**RE: Amity College New School Campus, Leppington (SSD-9227)**

**PROPERTY: 85 Byron Road, Leppington  
63 Ingleburn Road, Leppington  
Lots: 1 and 2, DP: 525996**

Council officers have undertaken a review of the DA and supporting information. This letter provides feedback on the DA for your consideration.

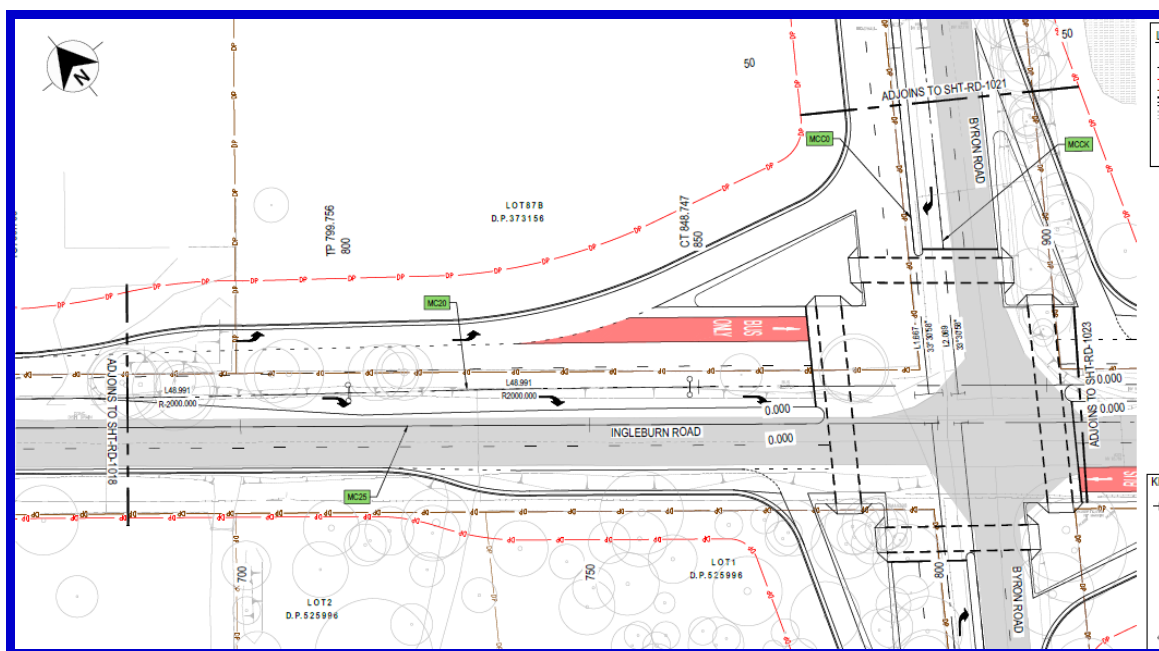
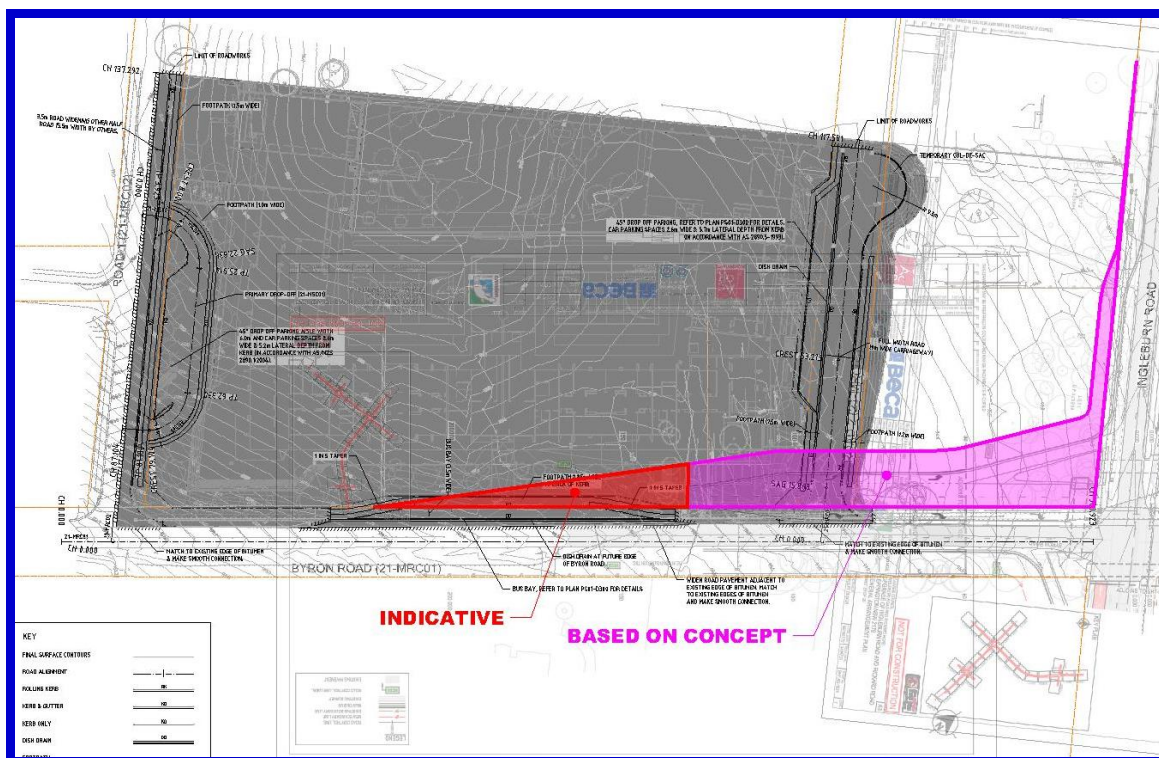
5. Roads 1 and 2 must be designed in accordance with Figure 3-14 of the Camden Growth Centre Precincts Development Control Plan (Growth DCP).
6. The dedication of road 2 to Council must include the footpath abutting the angled parking spaces along the north eastern side of the site.
7. The Growth DCP requires the development to provide 109 off-street car parking spaces and 104 have been proposed (excluding the on-site drop-off spaces along the south western side of the site). The development must provide a minimum 109 dedicated off-street car parking spaces in accordance with the Growth DCP.

Off-street car parking spaces compliant with the Growth DCP must be provided for the capacity proposed in each stage of the development.

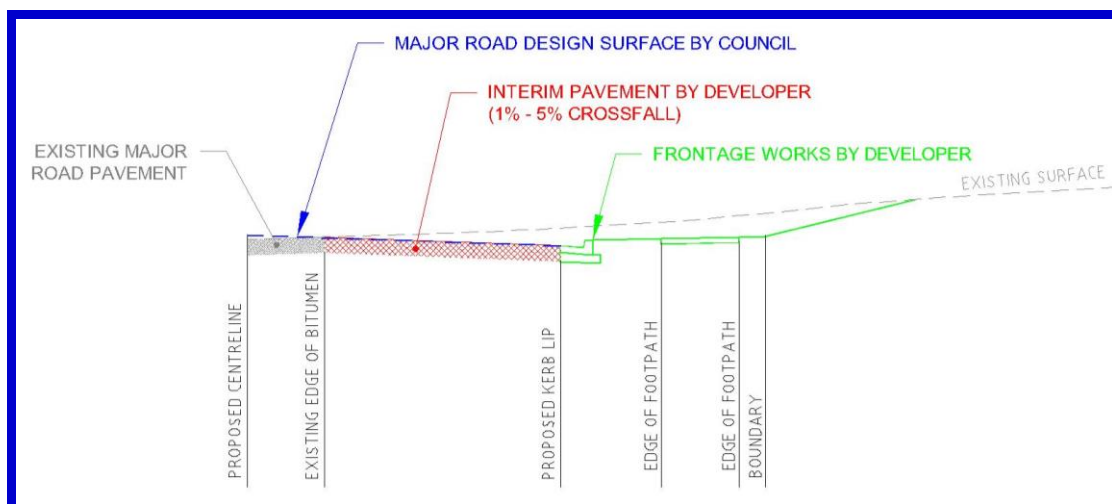
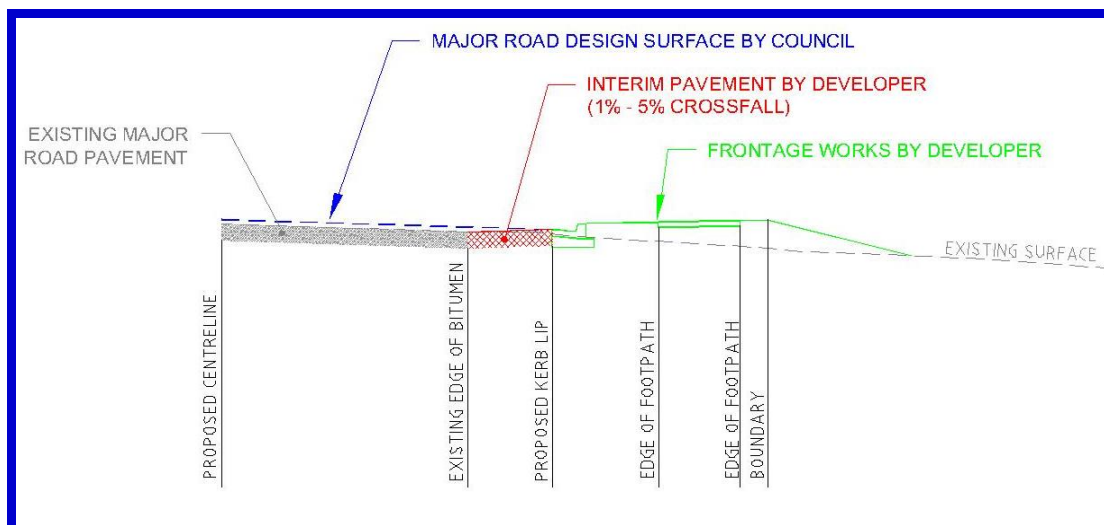
1. The development conflicts with Council's concept design for the future signalised intersection at Byron and Ingleburn Roads. The concept design is aligned with the department's Leppington Precinct Transport and Access Strategy. The concept design may require land from the site:

2. The proponent needs to consider Council's concept designs for Byron and Ingleburn Roads. The following works are required as part of the development:

- the proponent must design and construct Byron Road's frontage footpath, kerb, gutter and verge which must match into the concept design levels for Byron Road, and
- temporary road pavement must be designed and constructed along Byron Road (matching into Byron Road's frontage gutter lip level). Temporary cross fall grades at Byron Road must be between 1% and 5%:

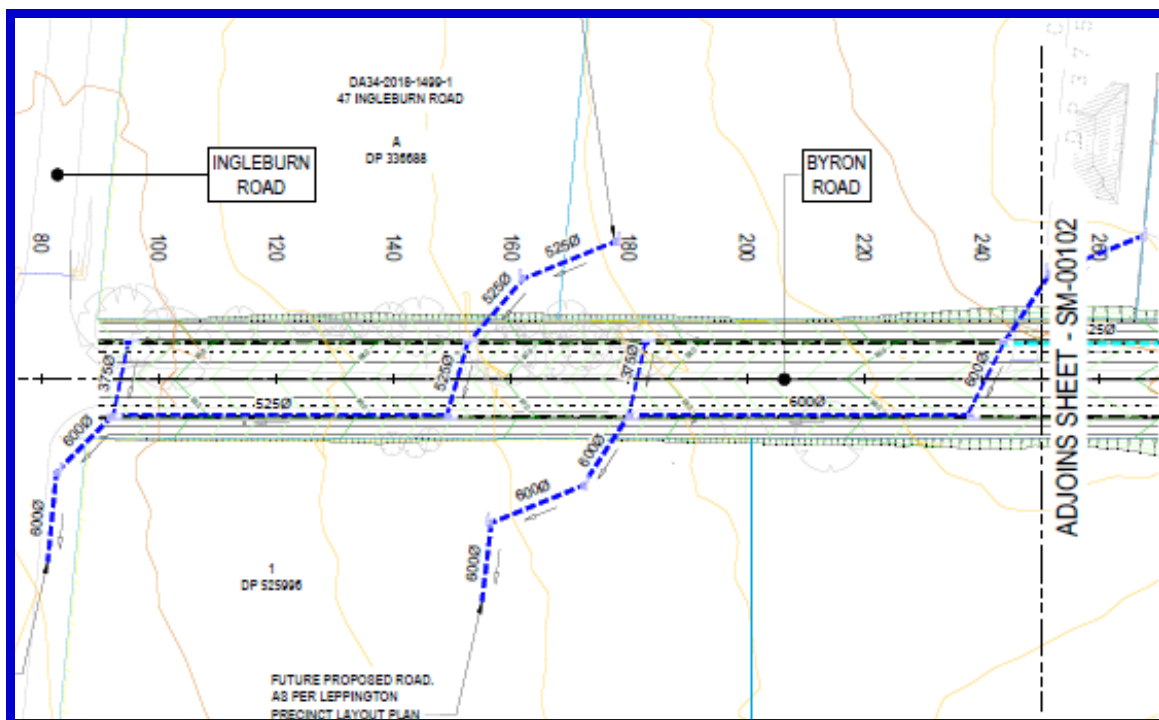
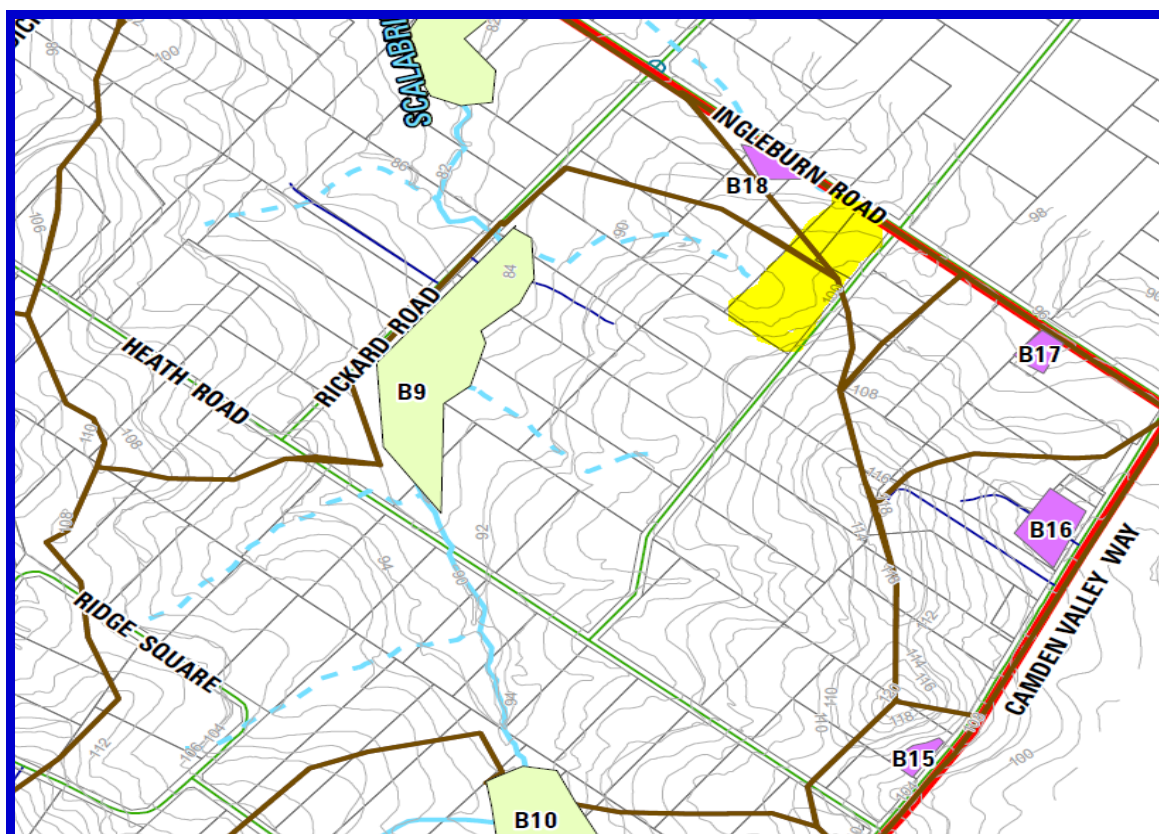
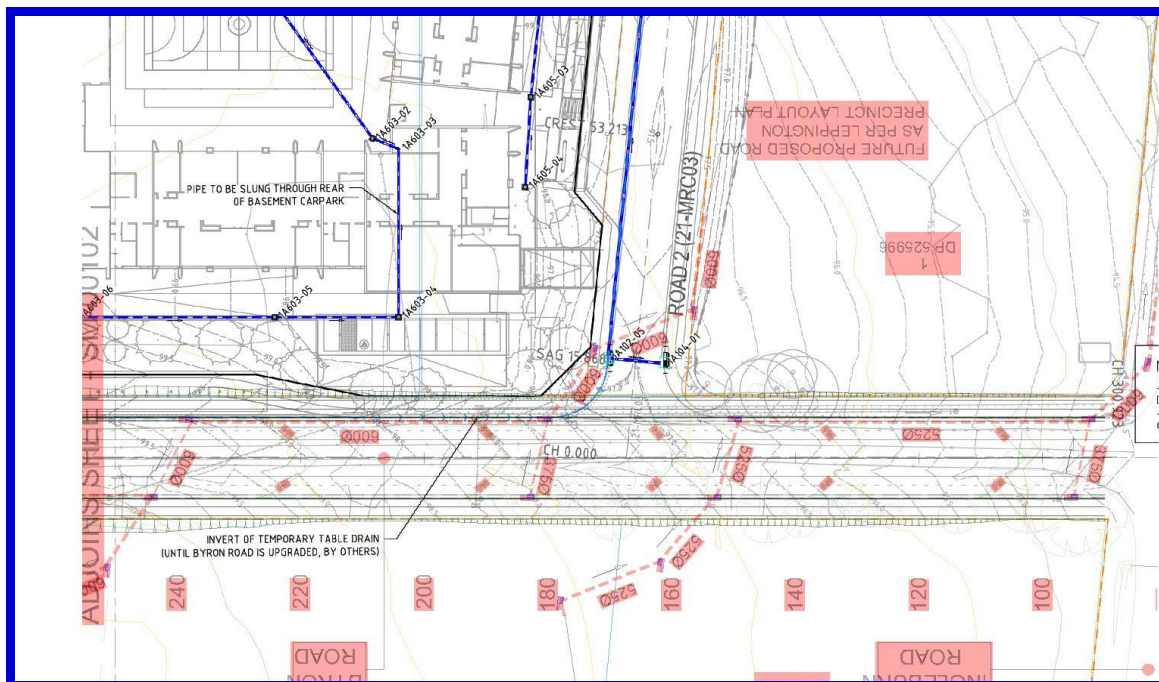
9. The proponent must design and construct Byron Road's drainage system, aligned with Council's concept design, which caters for the developed upstream catchment (and other DAs lodged with Council) in accordance with the Leppington Precinct Water Cycle Management Strategy (2012) by Parsons Brinckerhoff:

The Byron Road and internal site drainage system must accommodate the ultimate developed upstream catchment, in accordance with the Leppington precinct's indicative layout plan and the Leppington Precinct Water Cycle Management Strategy (2012) by Parsons Brinckerhoff:

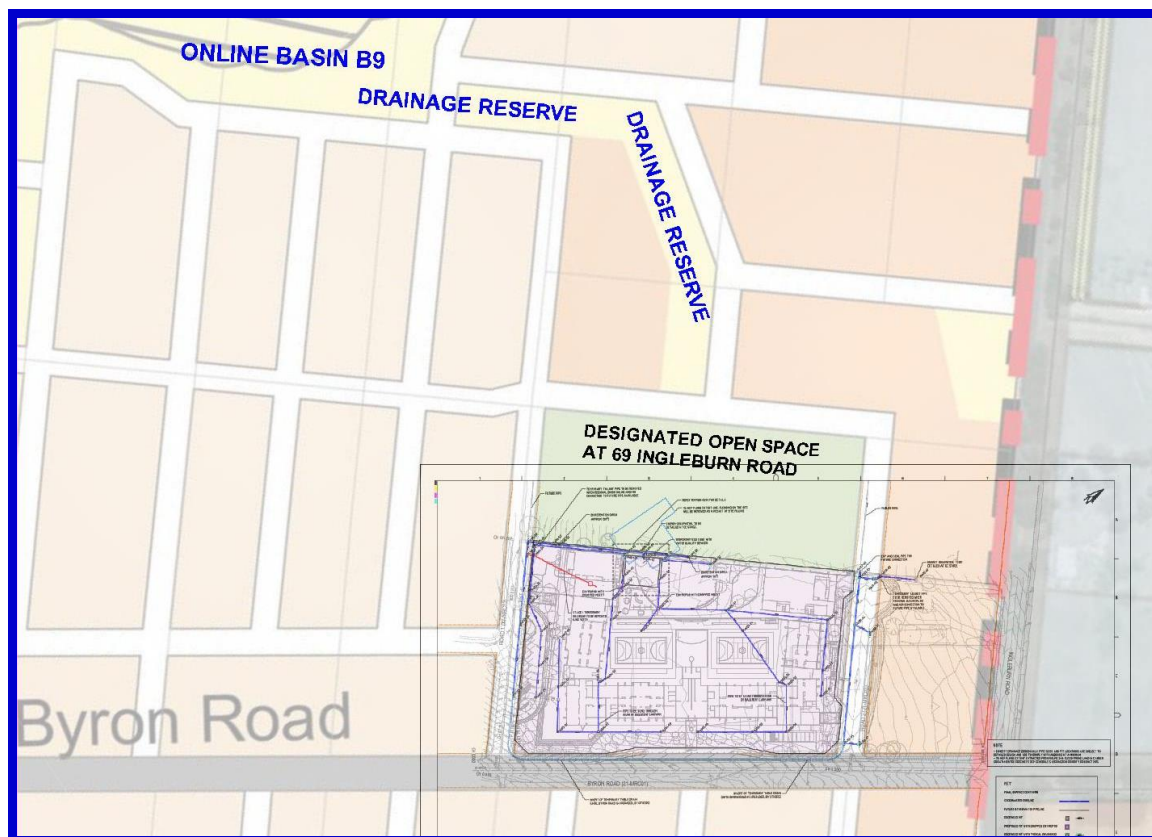
11. In accordance with the Leppington precinct's indicative layout plan and water cycle management strategy, the stormwater flows from 63 Ingleburn are to drain to the zoned drainage reserve near 75 Ingleburn Road. Due to these requirements, the following needs to be considered, modelled and incorporated into the drainage design:

- overland flows should not be conveyed through 69 Ingleburn Road as this site is zoned for public open space. A drainage swale is not appropriate through this space,
- the 1% annual exceedance probability (AEP) level flows, from the post development external (in accordance with the indicative layout plan and water cycle management strategy) and internal catchment, are to discharge into the drainage reserve and eventually online regional drainage basin B9, and
- the development and internal roads need to be at or above the post development flood planning level (not the existing flood planning level).
